Planning Statement

BANK FARM, HIGHER LANES, HIGHER
WYCH, WHITCHURCH, SY13 3AX

April 2024

'Works to widen and increase the height of the lean-to to rear of farmhouse along with rebuilding and change of use of piggery building to provide ancillary residential accommodation including glazed recessed linkway and hard landscaping (Part Retrospective)'.

SOUTH ELEVATION.

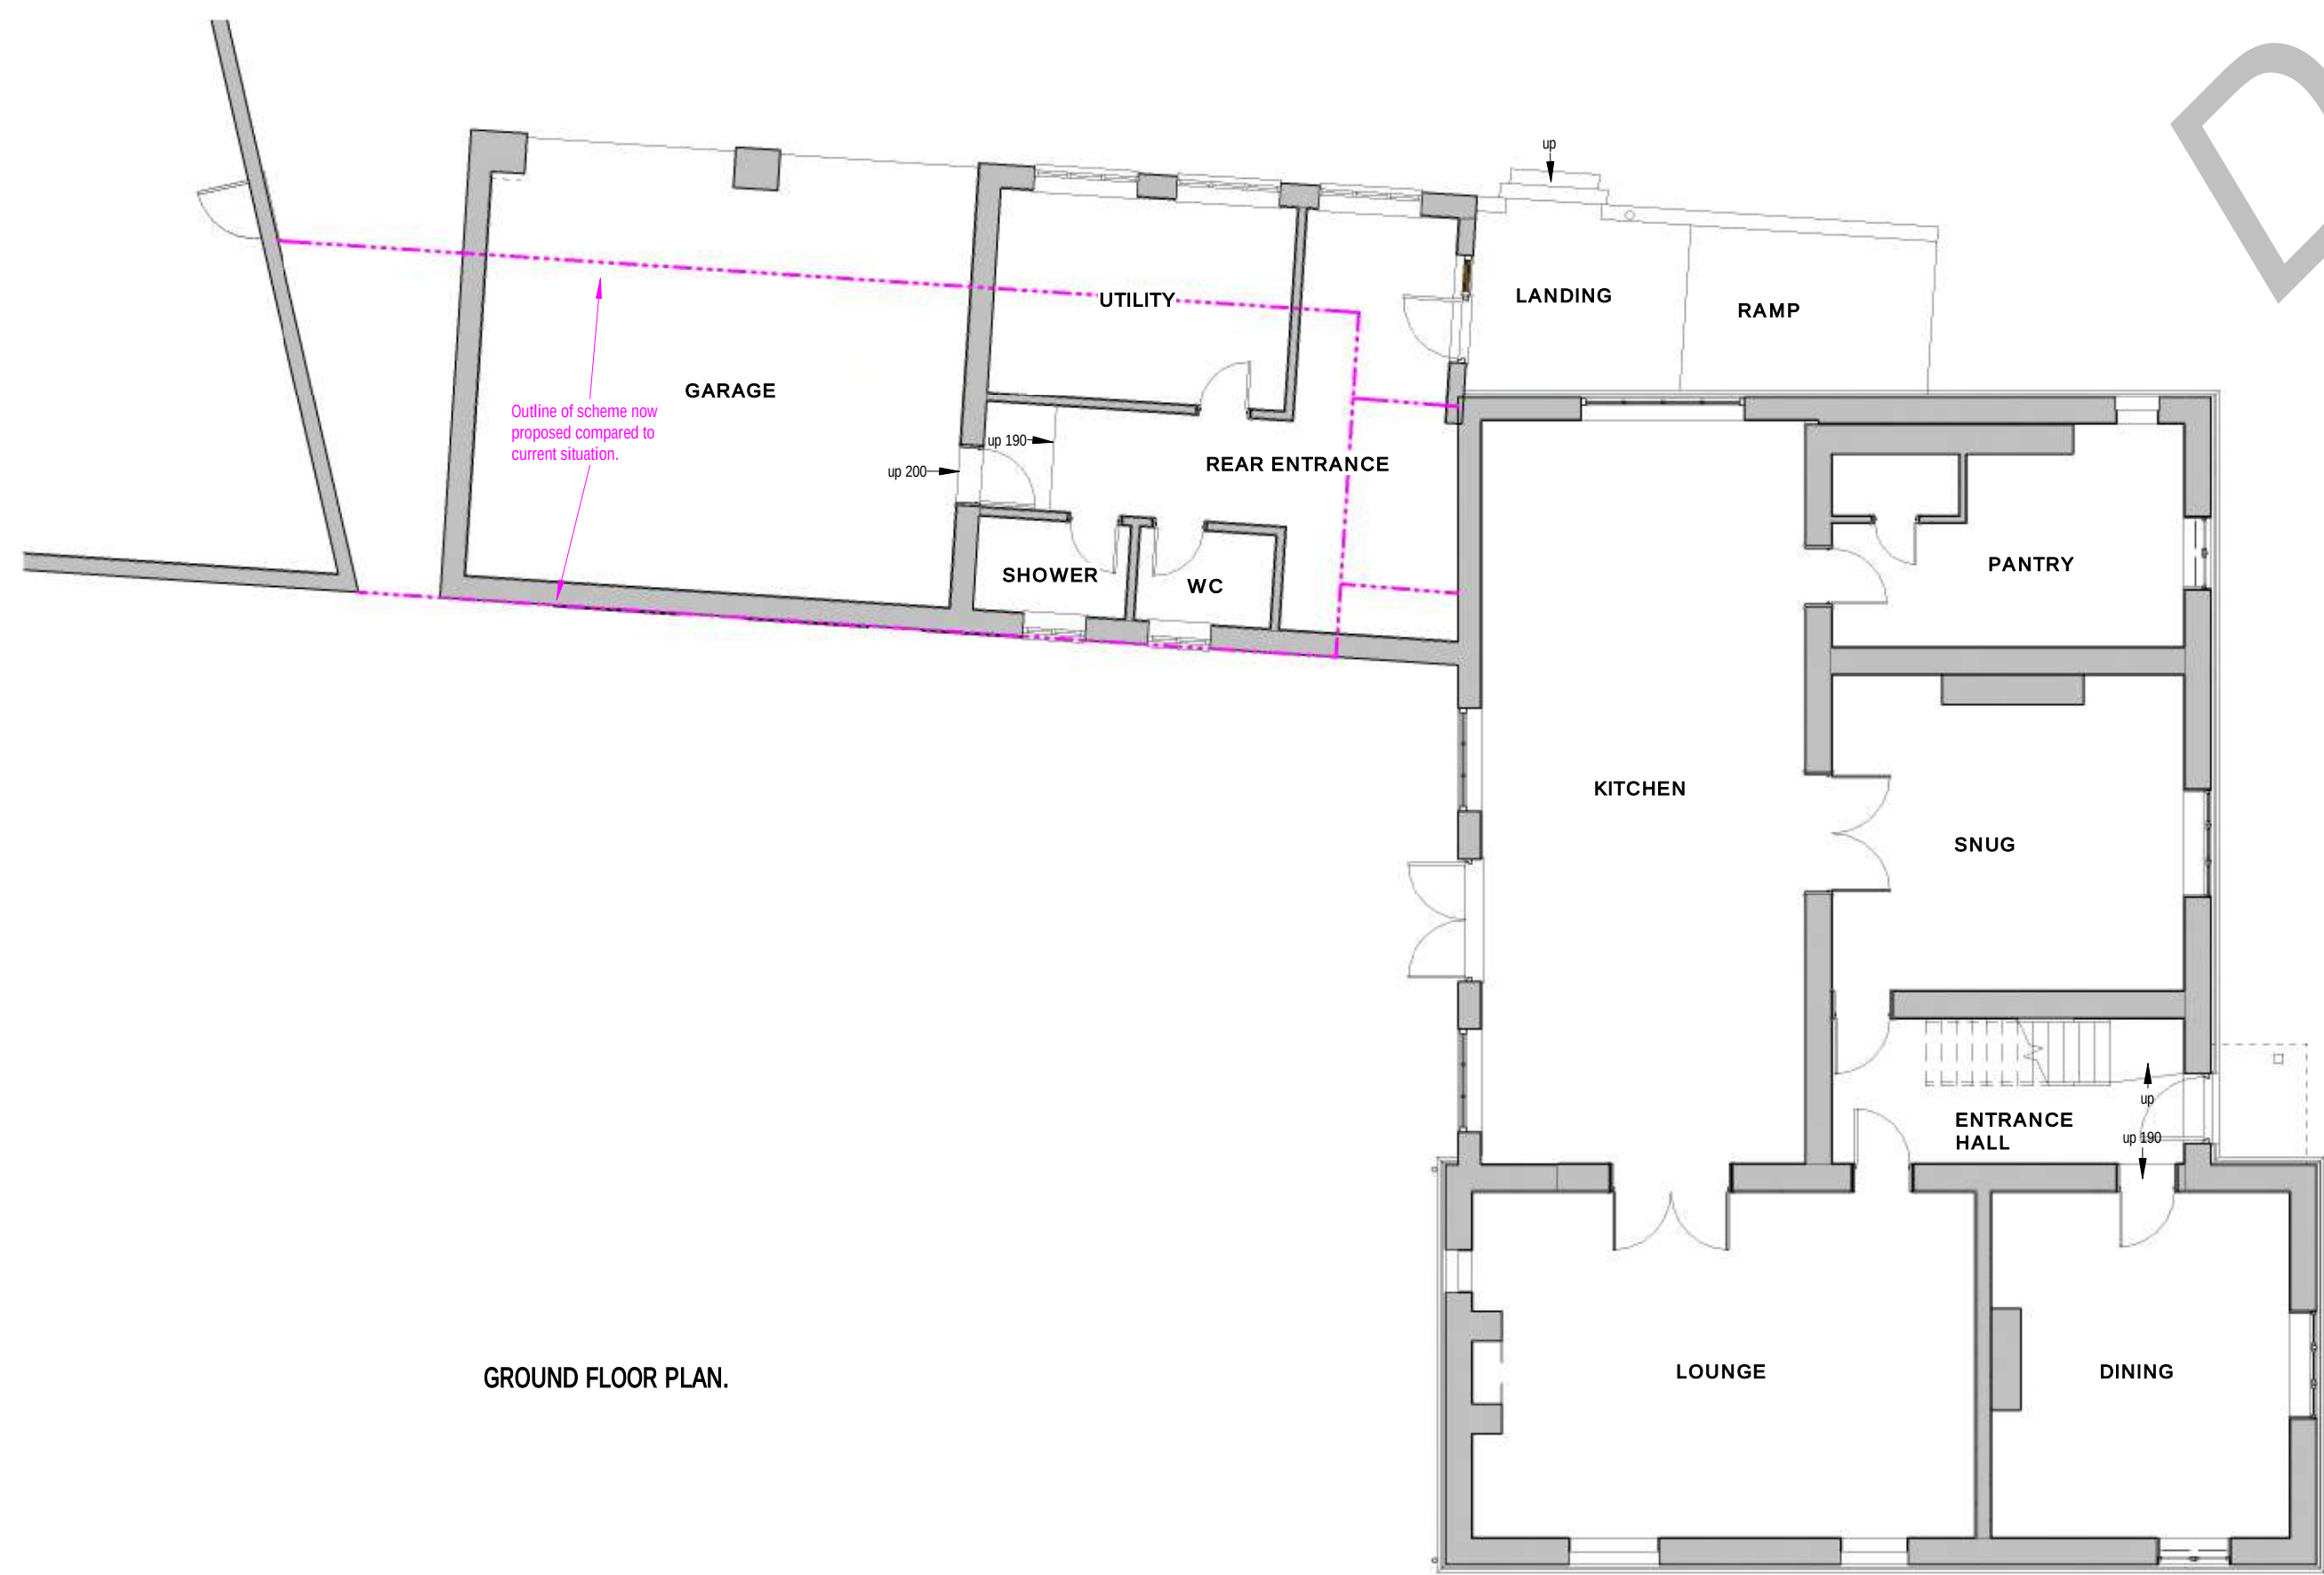
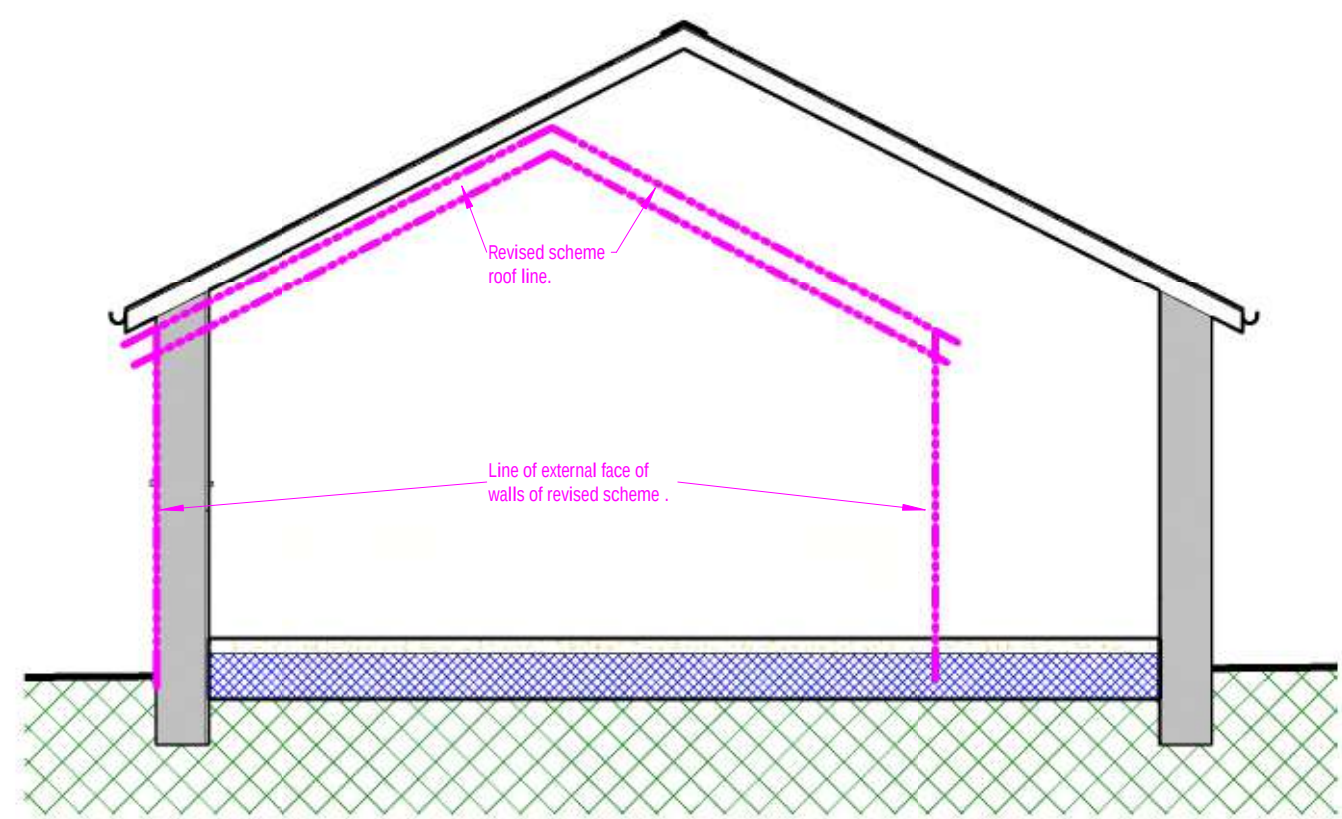
We think the proposals are positive and do a lot to address our main concerns, which was the separation of the Piggery from the multi-purpose barn range it was listed as part of. We would like to see an increase in the separation of the Piggery from the farmhouse as they were never intended to be linked, looking at the size of the rooms, the large utility room looks like it could be squeezed to achieve the reduction in length. At the same time, the link building could be extended to still provide the functional link desired. This element should be a very simple, lightweight linking structure and not compete visually or functionally with the farmhouse or barn.

Rev	Description	Date
a	Pre App Letter dated the 3 Feb 2023	17/2/2023
b	Planners email dated the 20/4/2023	20/4/2023
c	Link Amendment	28/4/2023
d	Piggery Partly retained	28/11/2023
